Year Three Monitoring Report

GROUNDHOG HOLLOW PROJECT

RE: Groundhog: Year 3 Monitoring Report (NCDMS ID 100049)

Listed below are comments provided by DMS on February 9th, 2024 regarding the Groundhog Mitigation Site: Year 3 Report and RES' responses highlighted in blue.

**Figure 2 - CCPV MY3
Groundhog Hollow
Mitigation Project**

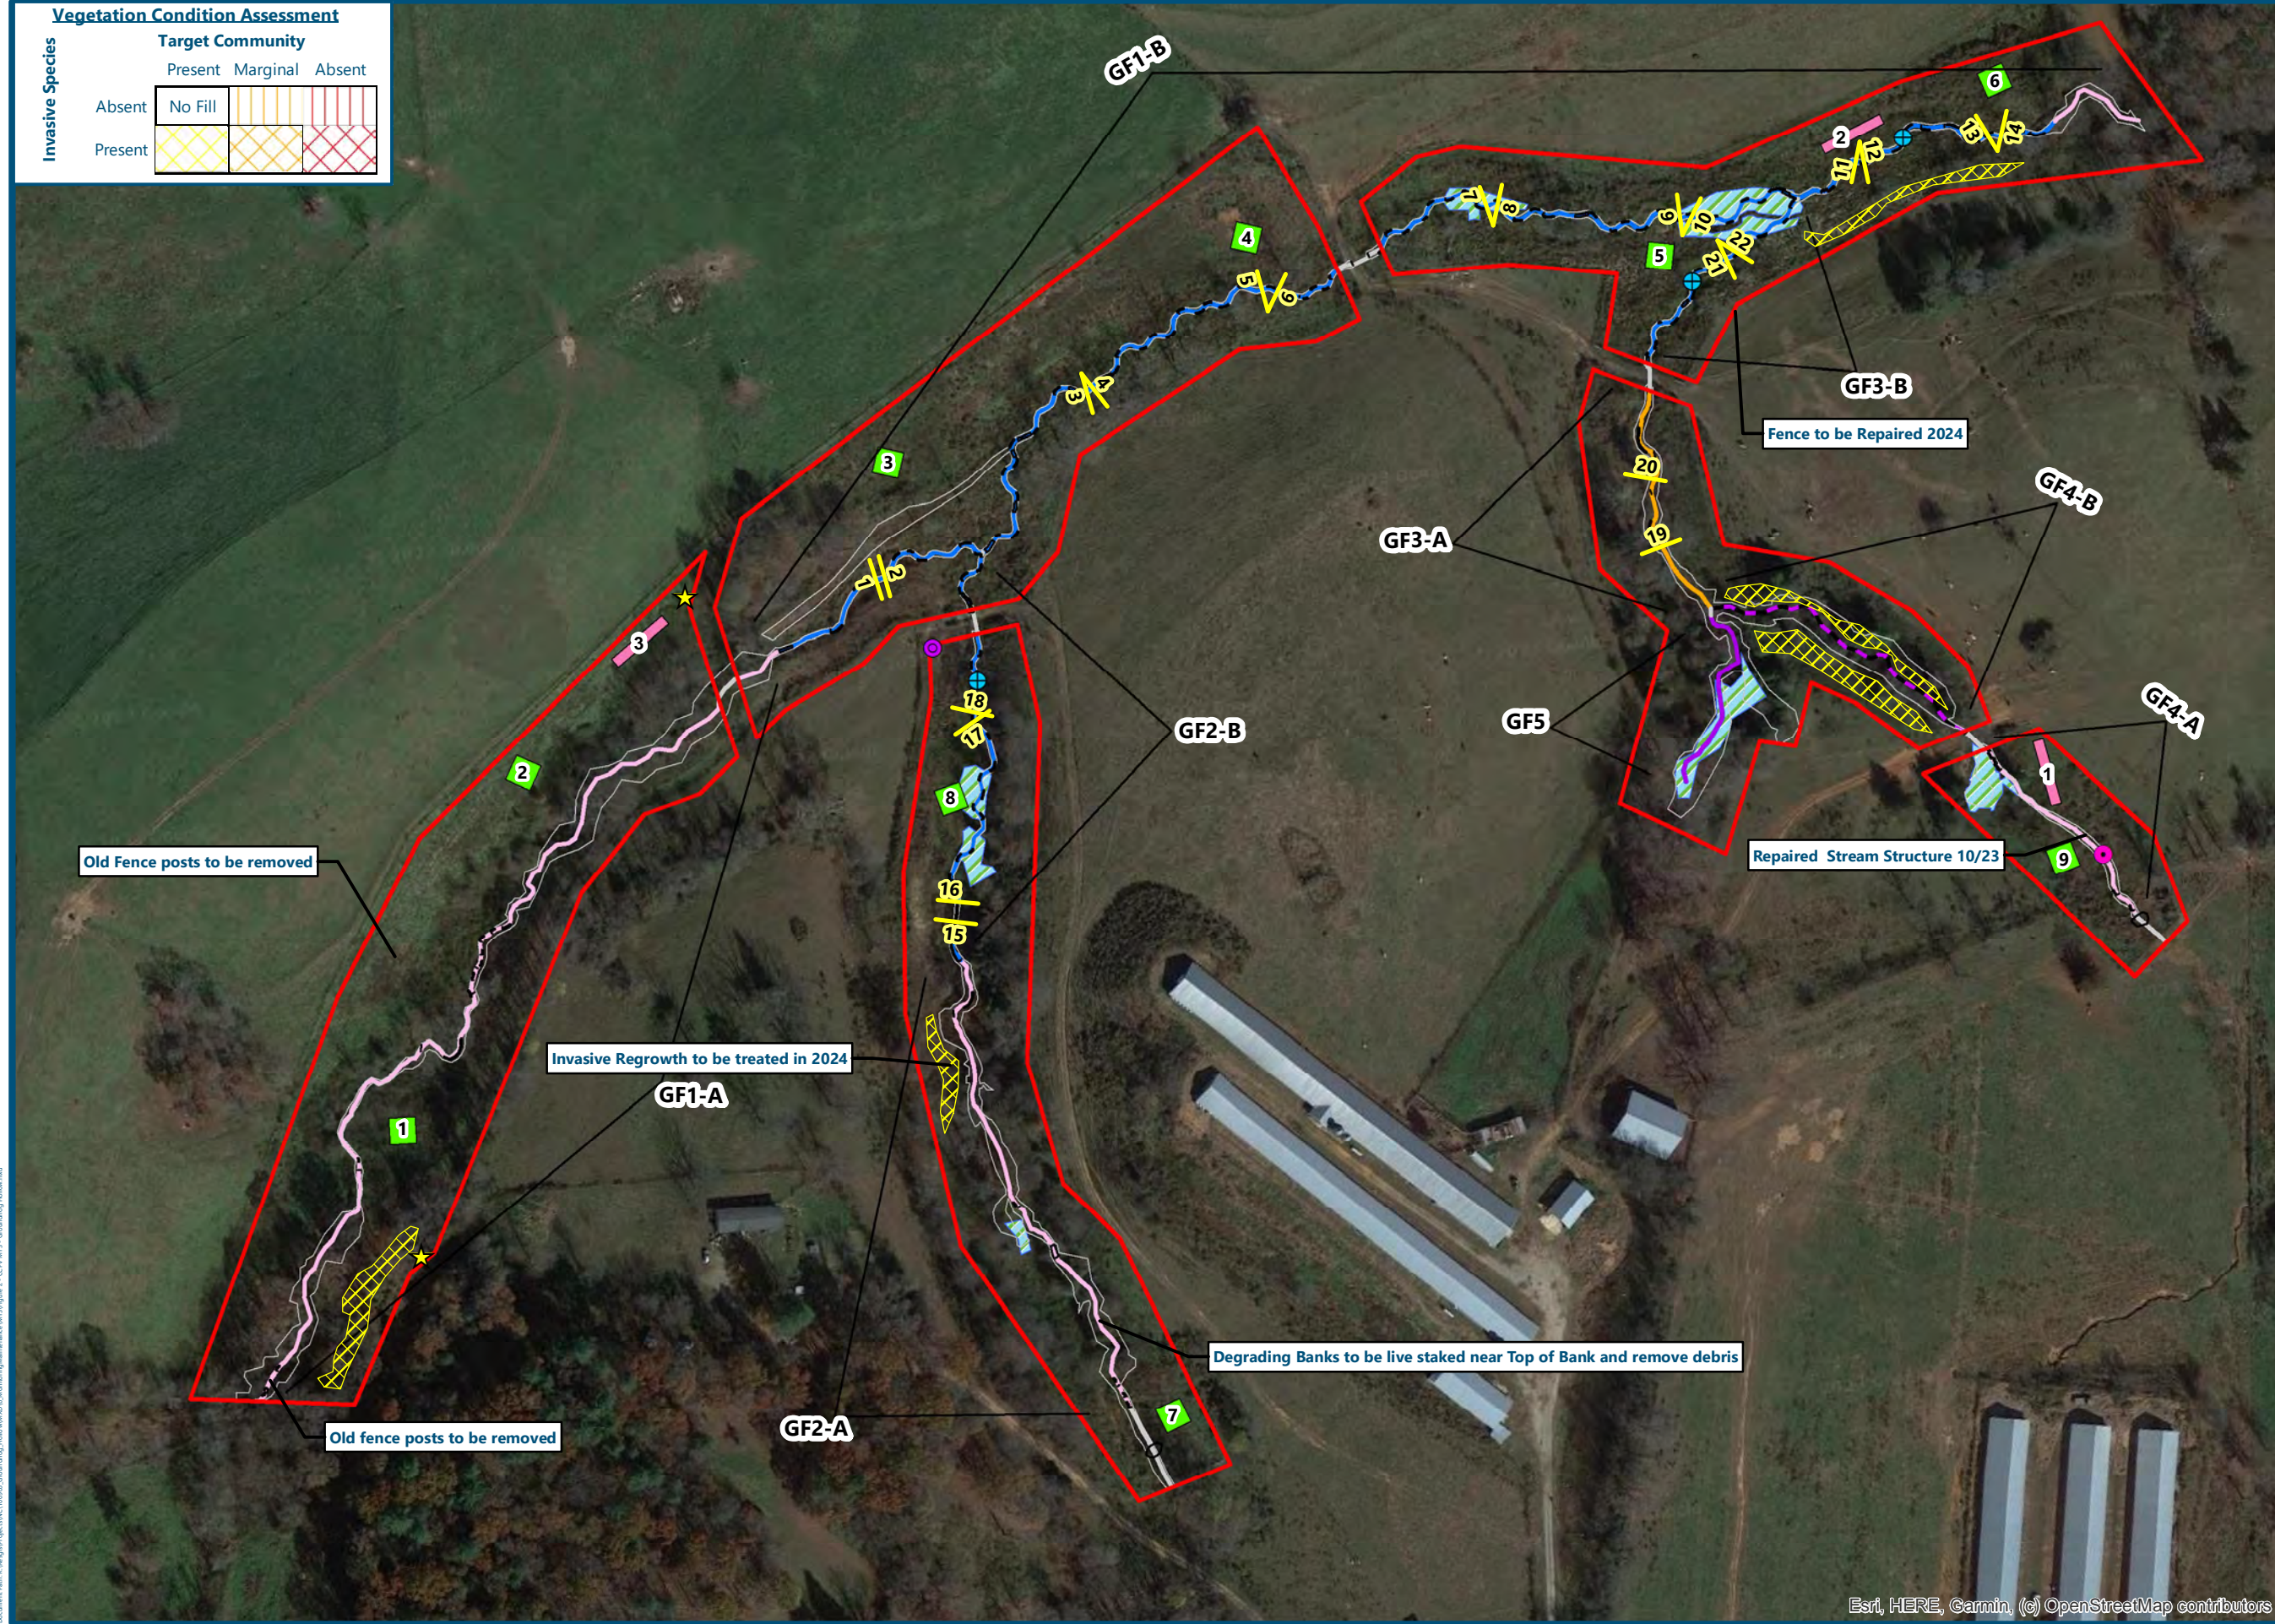
- Report Text/ Table 6/ CCPV Map: Significant amounts of invasive species were noted during the 11/14/2023 DMS site visit. The MY2 (2022) report text indicated that approximately 0.21 acres of Chinese Privet was “flush cut” in MY1(2021) and will require further invasive treatment in 2023. Chinese privet was also noted along GF1-A, GF1-B, GF2-B, and GF4-A during MY2(2022) and was proposed for treated in 2023. Was any invasive treatment completed in MY3(2023); if not, please explain why invasive treatment was not completed in the monitoring year as previously proposed by RES.
 - Invasives were treated via foliar spray in March 2023, Table 2 now details this. RES will continue to work to find the best methods for handling invasives on site.

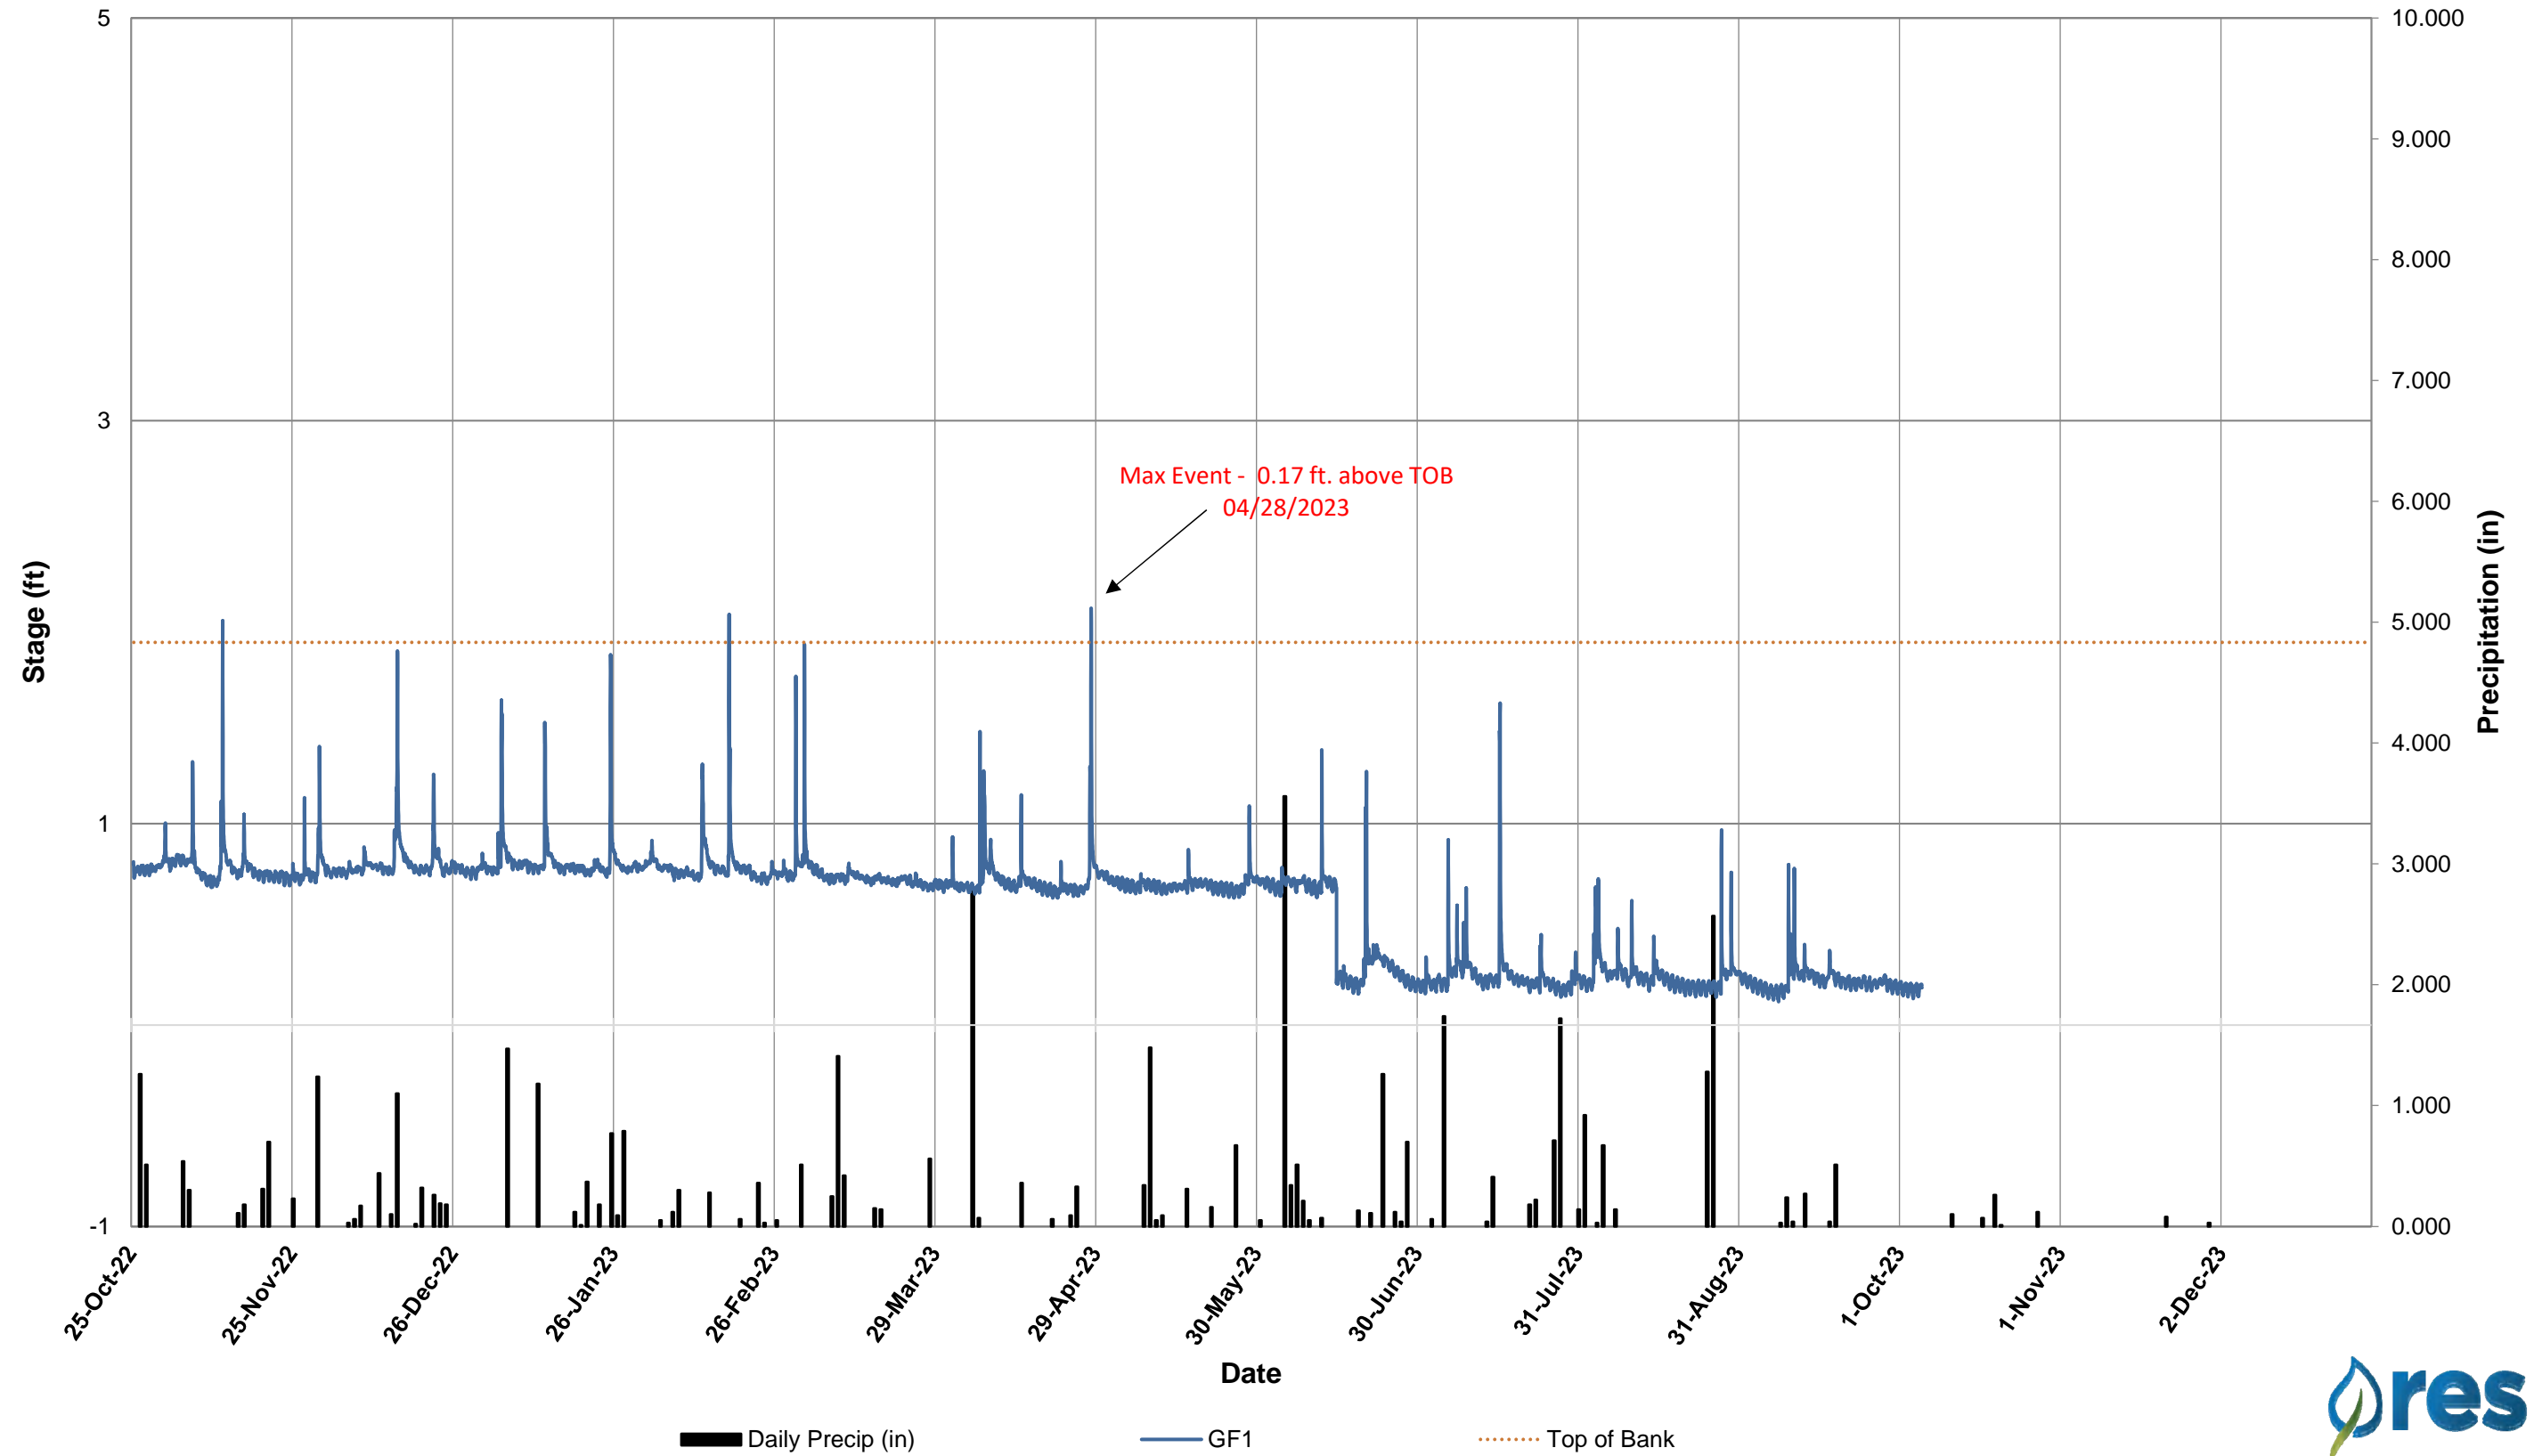
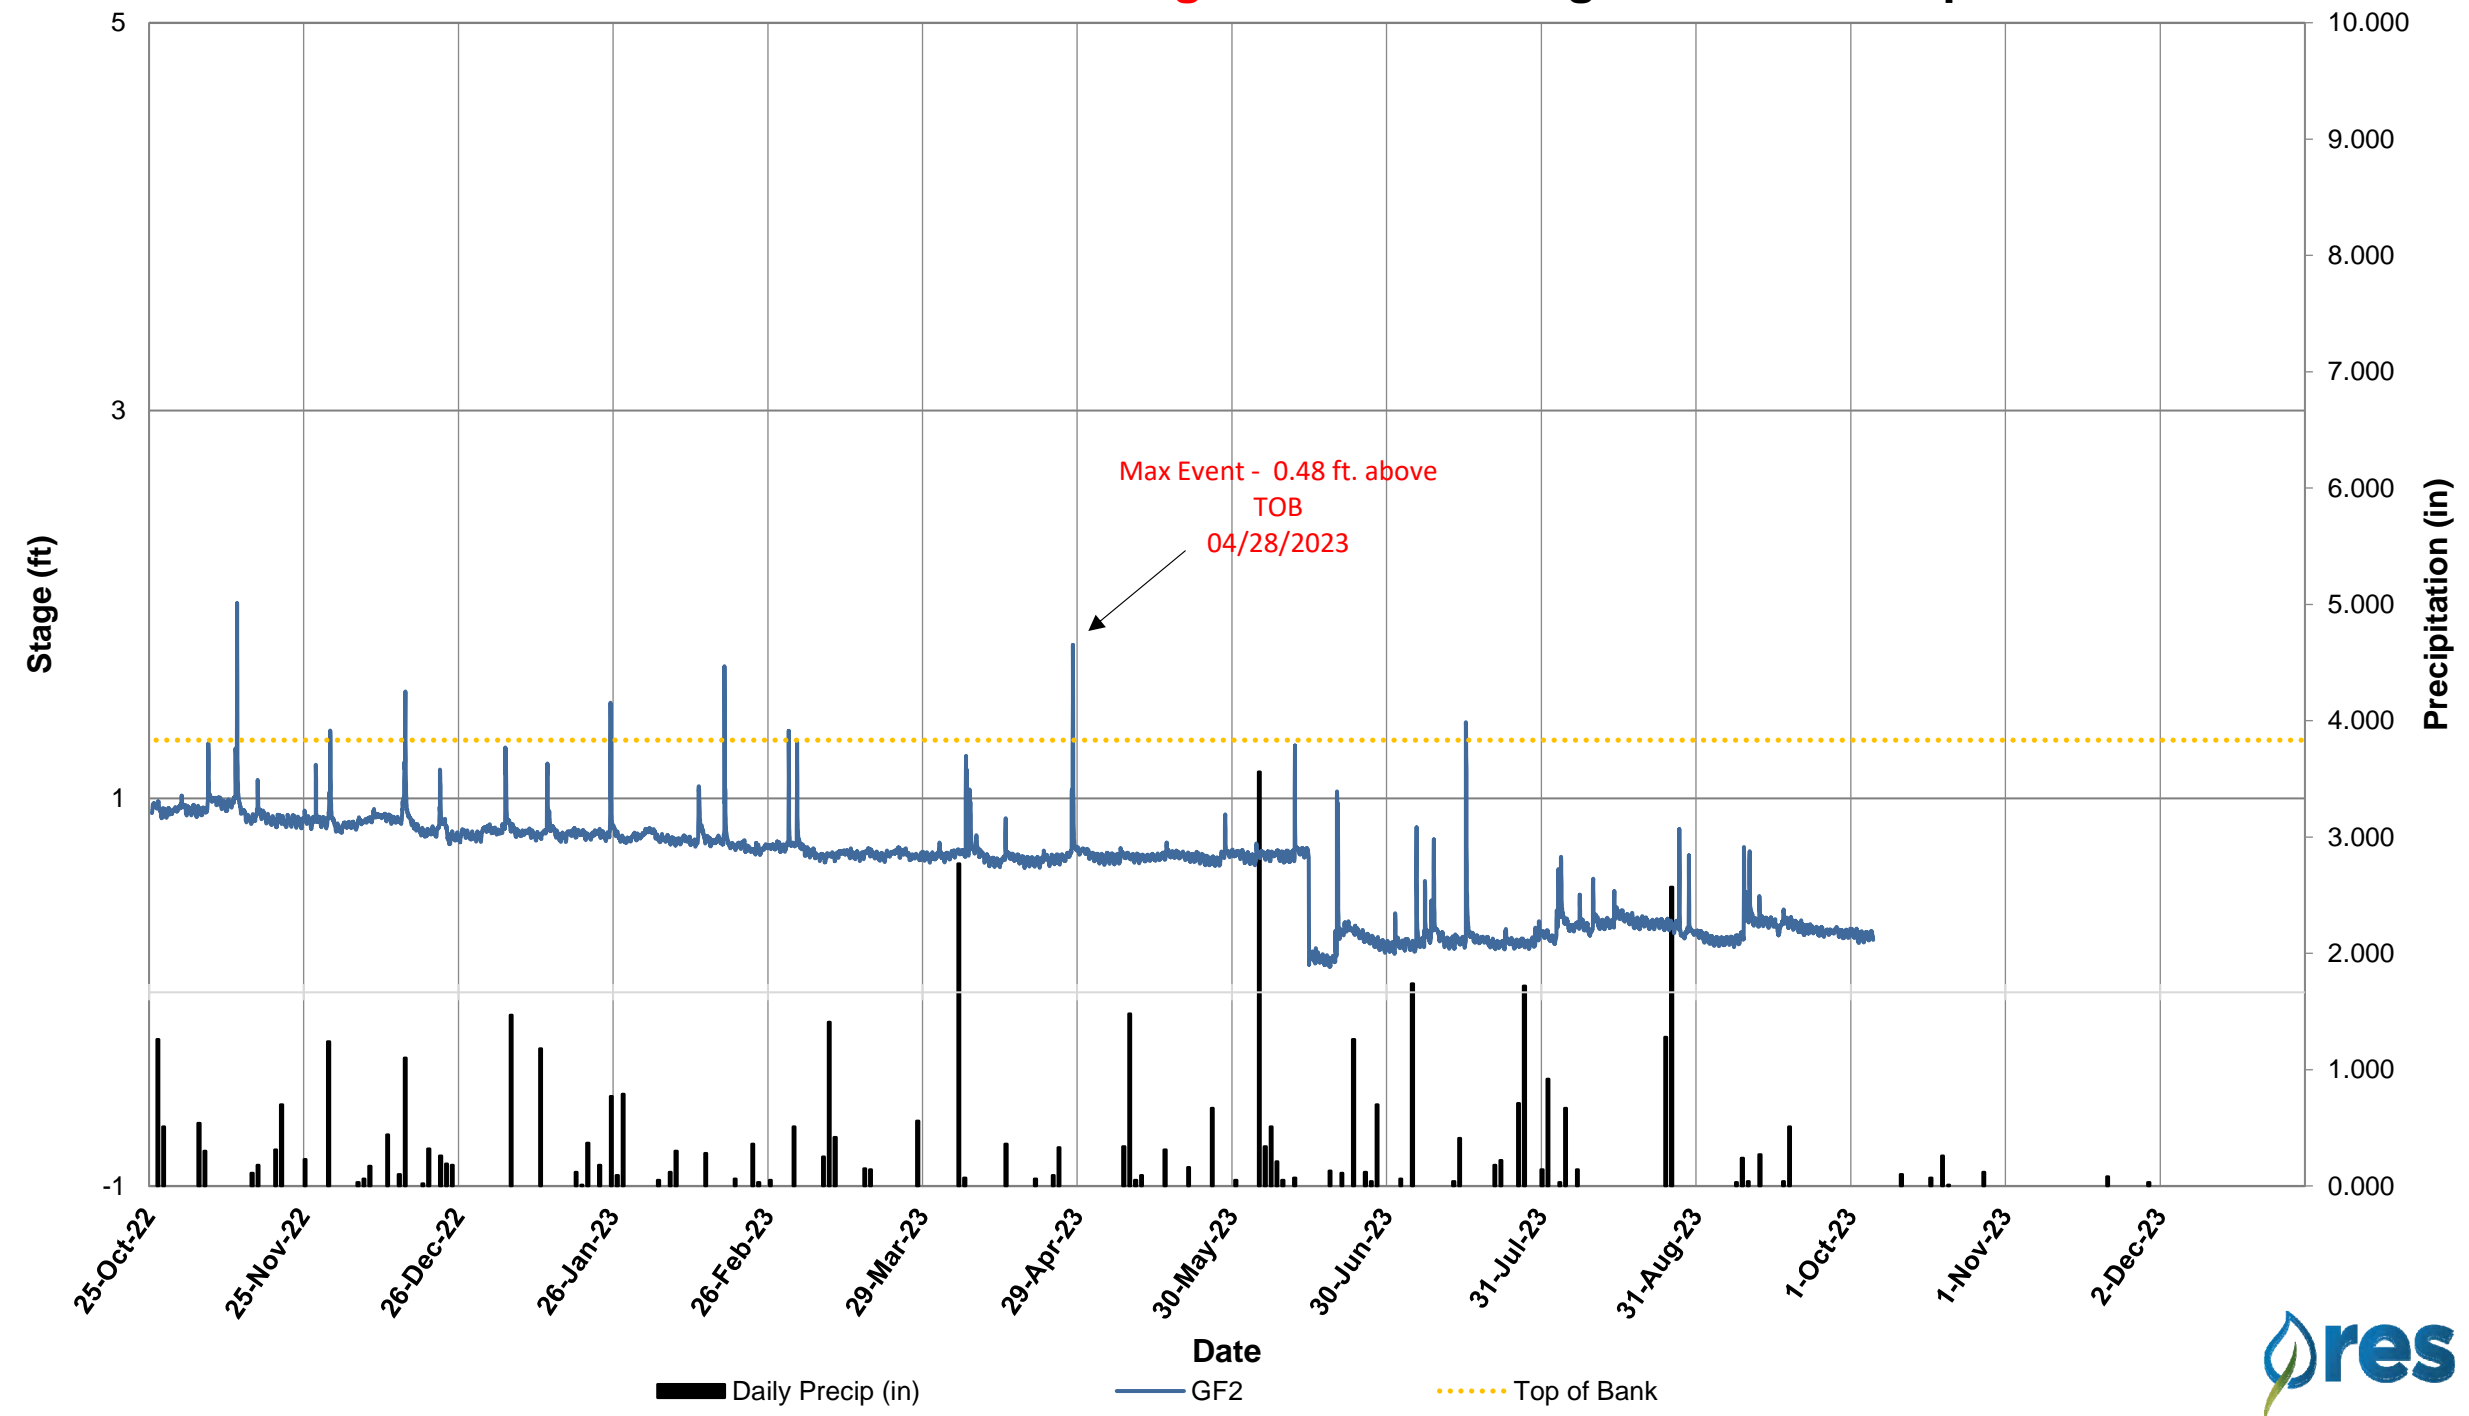
- The surface water graphs submitted were mislabeled as MY 2; the data appeared to be MY3 2023. Please review, verify and update accordingly. For future submissions, please check to ensure the data tables and graphs are labeled correctly.

- The labels for the MY3 2023 hydrographs have been updated and are included in the digital support files.
